Item Name: Quick Release Heli-Utility-Basket™ Long, HD Lid, Spacepod™/Squirrel Cheek Comp.

DART SERVICE INSTRUCTION

TO AMEND INSTALLATION INSTRUCTIONS D350-607-3 Rev.D,
INSTALLATION INSTRUCTIONS D350-607-4 Rev. C AND
INSTRUCTIONS FOR CONTINUED AIRWORTHINESS ICA-D350-607 REV. 6
REF TCCA STC: SH94-14
REF FAA STC: SR00213NY
REF EASA STC: EASA.10016996
REF BRAZILIAN STC: 2007S03-03/-04/-05/-06

A	NEW ISSUE	AJS	14.05.16
REV.	DESCRIPTION	BY	DATE
DESIGN	AJS	DART AEROSPACE LTD HAWKESBURY, ONTARIO, CANADA	
DRAWN	AJS		
CHECKED		DRAWING NO.	REV. A
MFG. APPR.	N/A	DSI 9699	SHEET 1 OF 2
APPROVED		TITLE	SCALE
DE APPR.		LUG REPLACEMENT	NTS
DATE	14.05.16	COPYRIGHT © 2014 BY DART AEROSPACE LTD THIS DOCUMENT IS PRIVATE AND CONFIDENTIAL AND IS SUPPLIED ON THE EXPRESS CONDITION THAT IT IS NOT TO BE USED FOR ANY PURPOSE OR COPIED OR COMMUNICATED TO ANY OTHER PERSON WITHOUT WRITTEN PERMISSION FROM DART AEROSPACE LTD.

FIGURE 1: INSTALLATION OF D4775-041 FWD STRUT

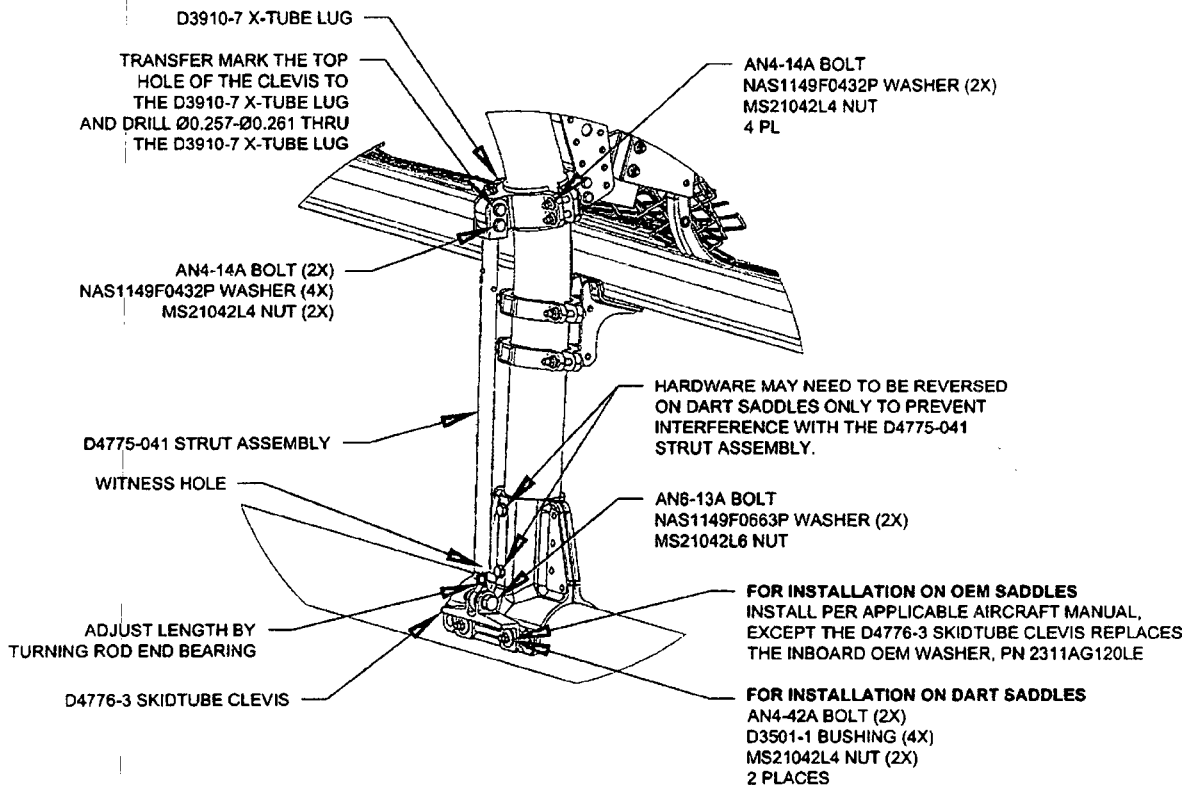
3.1 Substitute the Forward Lower D3910-5 X-Tube Lug with the D3910-7 X-Tube Lug as shown in Figure 1.

3.2 Install the forward D4775-041 Strut Assembly. Transfer mark from the upper hole on the clevis of the D4775-041 Strut Assembly to the D3910-7 X-tube Lug and drill thru the lug $\varnothing 0.257$ - $\varnothing 0.261$ as shown in Figure 1. Touch up chemical conversion coating per MIL-DTL-5541. Check the witness holes located at the bottom end of the D4775-041 Strut Assemblies to ensure that the thread from the rod end extends past the witness hole.
Torque MS21042L4/-4 nuts to 50-70 in-lbs (5.7-7.9 N-m). Torque MS21042L6/-6 nuts to 160-190 in-lbs (18.1-21.5 N-m).
